COMMITTEE REPORT

BY THE DIRECTOR FOR ECONOMIC GROWTH AND NEIGHBOURHOOD SERVICES
READING BOROUGH COUNCIL
PLANNING APPLICATIONS COMMITTEE: 2nd February 2022

App No.: 210544/FUL

Proposal: Vehicular access with permeable surface on land south of Mill Green to provide access to The Moorings

EXISTING
TYPICAL SECTION "AA"

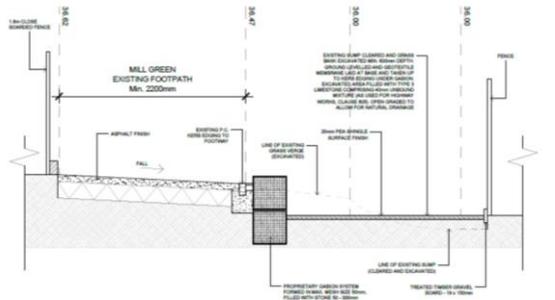
It can be seen that the works include 'clearing and excavating' the line of the existing stump (whatever that entails), building up the ground levels within the sump closest to the boundary and excavating the grass verge to bring the ground level down, along with installation of edging gabion.

It can be seen from the TPP that the RPAs of trees Willow A, Ash B, Ash C, Hawthorn and H1 Cypress screen extend across the sump and beyond. Any roots present in ground to be excavated will therefore be removed. In addition, the arb report (par 6.23 & 12.5) states: 'A *geo-textile membrane will be laid to add strength to the sub-base surface and protect the underlying soil profile*'. I am not clear how a geotextile membrane will add any strength? It is a membrane that will act to avoid mixing of the infill stone and soil beneath and should allow water through (as long as the infill has no fines within it) but it won't prevent compaction of the ground

Proposed Section Plan 106 C, submitted 1/11/21 (my comments of 11/11/21 focused on the arboricultural response also received on 1/11/21 rather than the plans provided).

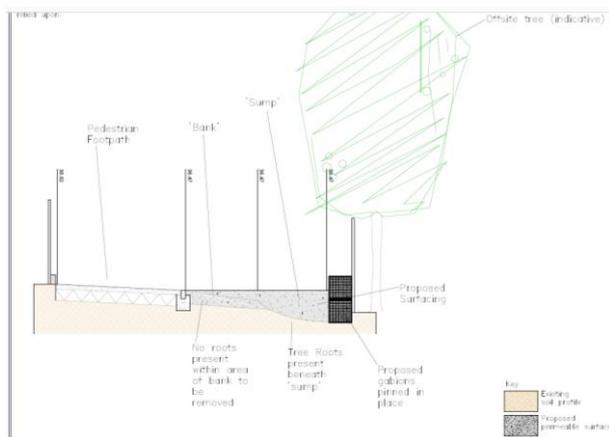
The ground works, as shown on the immediately above extract and explained in the arboricultural letter, confirm that excavation of the bank is required but that there are ‘no roots present’ in that area - I am not clear how this has been established with the TPP showing the RPAs extending to include this bank and 6.18 of the submitted AIA/AMS stating: *‘The exact distribution of roots could only be confirmed by undertaking further site investigations such as trial trenches’*. There also remains the question of compaction of the ground during infill of the stump (the ground beneath this containing roots). I am still unclear how this is to be avoided.

Generally, I am satisfied with the proposals now in relation to trees, however a revised AMS is required and should ideally be submitted prior to a decision in order to avoid a pre-commencement condition. This should be as succinct as possible and in addition to relevant information included in the current AMS should be amended to refer to the latest proposals (plans), provide the clarity included within the arboricultural letter of 17/12/21, clarify how compaction will be avoided and detail the works with H1 (referred to above). Hopefully this will not be too onerous.

SCALE 1:250 @ A3	DATE 20.10.21
DRAWN OE	CHECKED GB
DRAWING NO.	101
JOB NO.	REVISION C

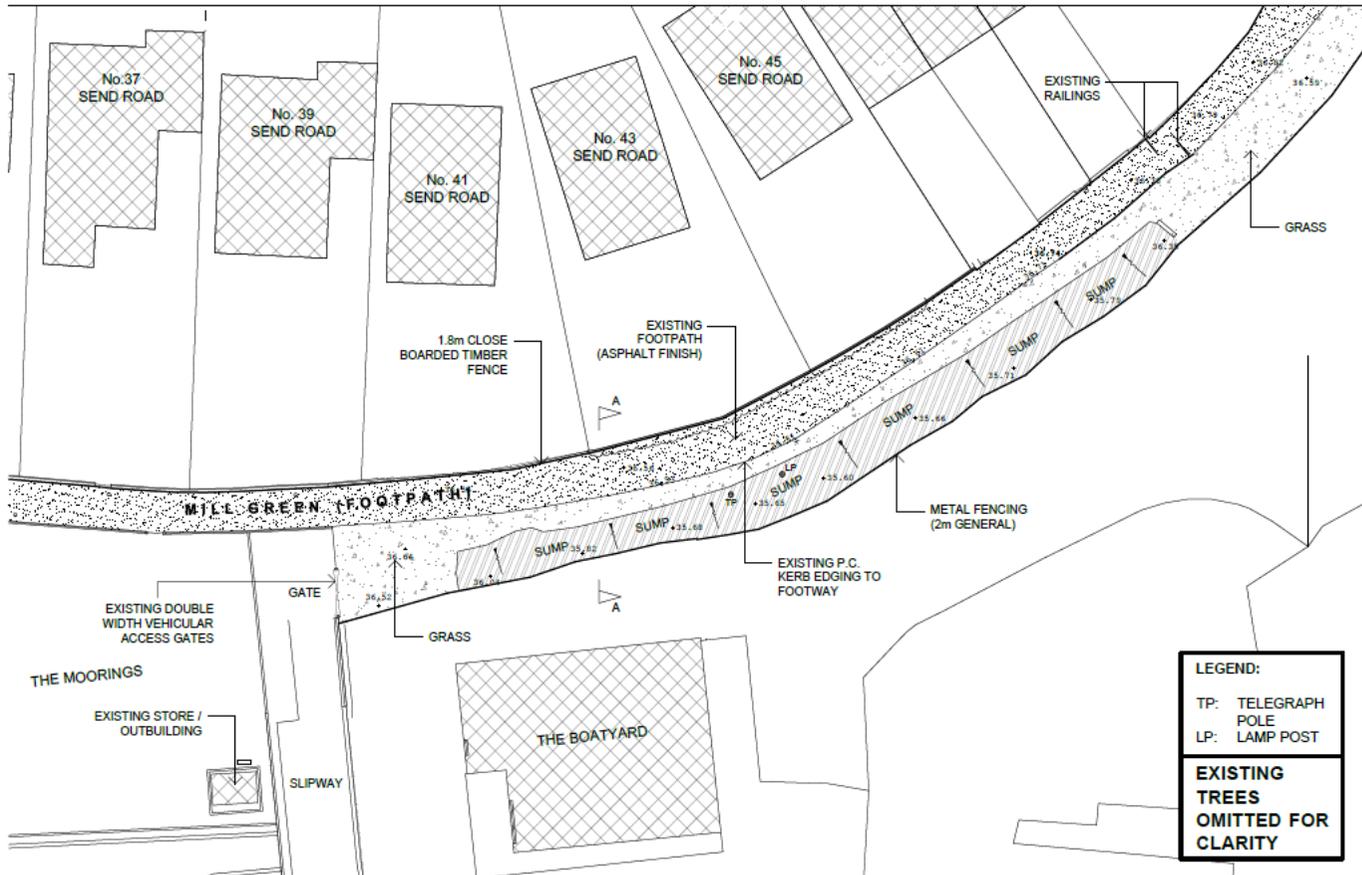
- detail the existing ground levels at the site in sufficient detail (spot levels within the site shown on drawings 101 and 102 are sparse and do not provide sufficient coverage);
- detail the proposed ground levels at the site in a consistent manner or in sufficient detail to allow the effects on flood storage and flood conveyance to be properly assessed in the FRA;
- detail acceptable fence details for the development (see advice below);
- demonstrate that there is no loss of floodplain storage volume or adverse effects on flood conveyance as a result of the development.

The applicant should provide detailed topographic surveys showing the existing site levels and detailed drawings showing the levels of the proposed development. Site levels need to be stated in relation to the Ordnance Datum (the height above average sea level). You may be able to find Ordnance Datum information from the Ordnance Survey. If not, you'll need to get a land survey carried out by a qualified surveyor.

SCALE: 1:200 @ A3	DATE: 20.10.21
DRAWN: OE	CHECKED: GB
DRAWING NO:	104
JOB NO:	1E1120
DATE:	C

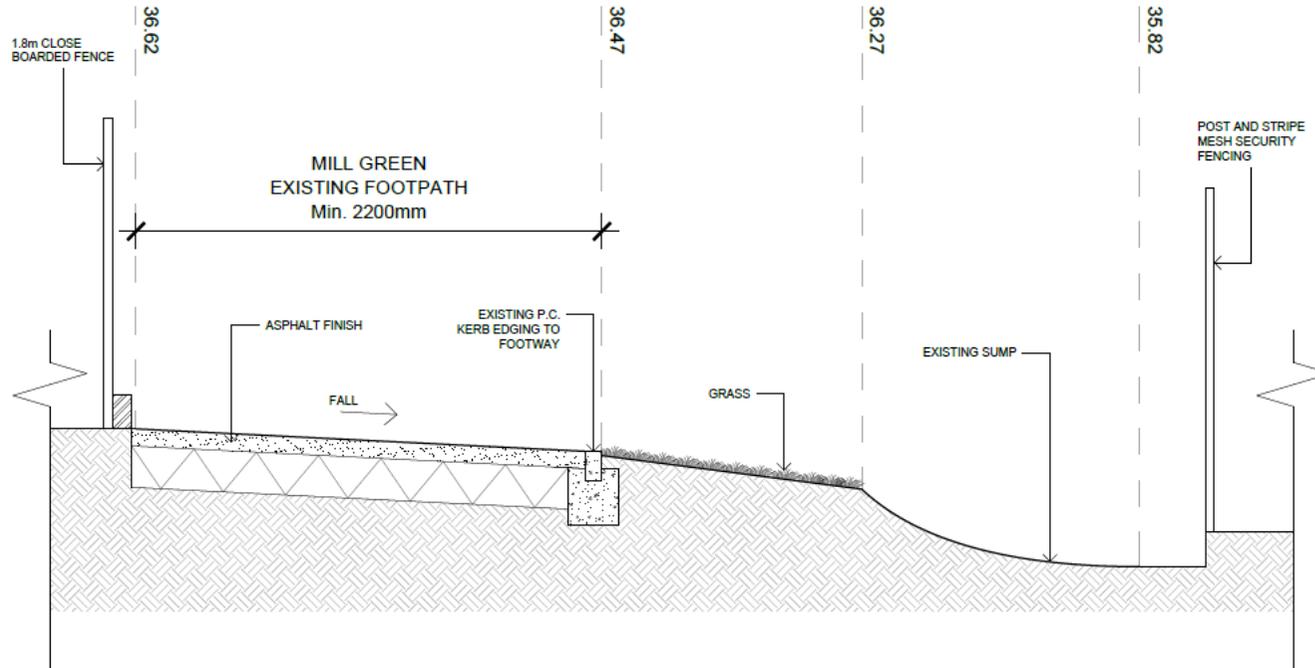
Irrespective of the above, Drawing No: FP/MGBHCB/01 B and Drawing 104 Rev C in particular at the western extremity of the proposed access road the road surface would be separated from the existing footway by a standard flush edging. This would also be unacceptable to the Highway Authority as this is likely to result in conflict between vehicles and pedestrians. It has been claimed that the route will be used solely by the applicant for the purpose of visiting / using the motorboat to be moored at the site and that usage of the access road will be infrequent and no more than twice a week (2 arrival trips + 2 departure trips). However, the use of the site is not party to this application and the applicant has provided no evidence to confirm the existing use of the land in question, therefore the road must be assessed on its own merits and therefore it must be designed to accommodate two-way traffic flows. In addition to this I reference the FRA submitted alongside the application, this states at Paragraph 2.2.2 that the commercial use of the boatyard has not been abandoned, this therefore identifies that the proposed access would generate a greater use than specified. As a result the proposed reduced width cannot be supported and a vertical separation would be required between the proposed access and the footway to ensure that vehicles do not overrun the footway so as to pass another vehicle.

Looking at Proposed Site plan 104 C and Proposed Section 106 the assumption was when looking at the section plan that gabions would only be placed within the sump and nowhere else which would be acceptable in tree terms as there would be no excavation into the existing ground (roots are likely to be present under the sump). However, I note that whilst reference to these gabions is made on the Site plan, it does not show the extent of these hence we do not know for sure that they are not proposed outside the sump - it would be an assumption. Without a revised site plan, there isn't that clarity hence impact on trees (offsite, on the boundary) is unclear as we don't have the confirmation that excavation for gabions outside the sump, i.e. into the existing ground level, is not proposed. In conclusion that if determining at this time, agree that this matter should be included as a reasoning for a refusal of permission.

LET M L Carter	SCALE 1:20 @ A3	DATE 21.06.21
TITLE Reinstatement of access drive at The Moorings, Mill Green, Cerebrith, Reading, Berkshire, RG6 5GL	DRAWN OE	CHECKED GB
TITLE Proposed Section	DRAWING NO. 106	JOB NO. FEEDIN A

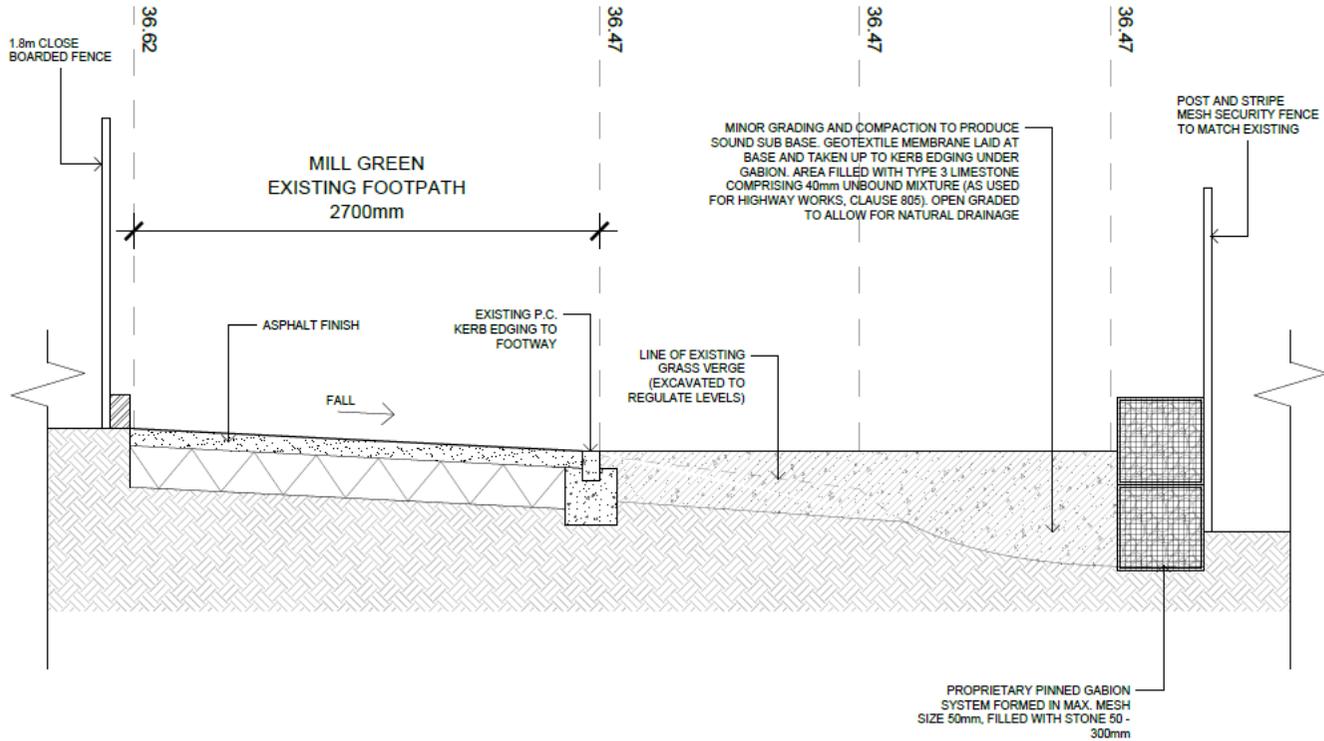
Drawing 106 Revision A accompanying the application, shows a typical section through the proposed works. This demonstrates that the proposals will alter ground levels and therefore have a potential impact on flood storage and flood conveyance. The proposed levels for the access road shown on the typical section are substantially lower (being 36.0m AOD) than those indicated on the Proposed Site Plan of the proposals shown on Drawing 104 Revision A (greater than 36.5mAOD). The proposal drawings are therefore inconsistent.
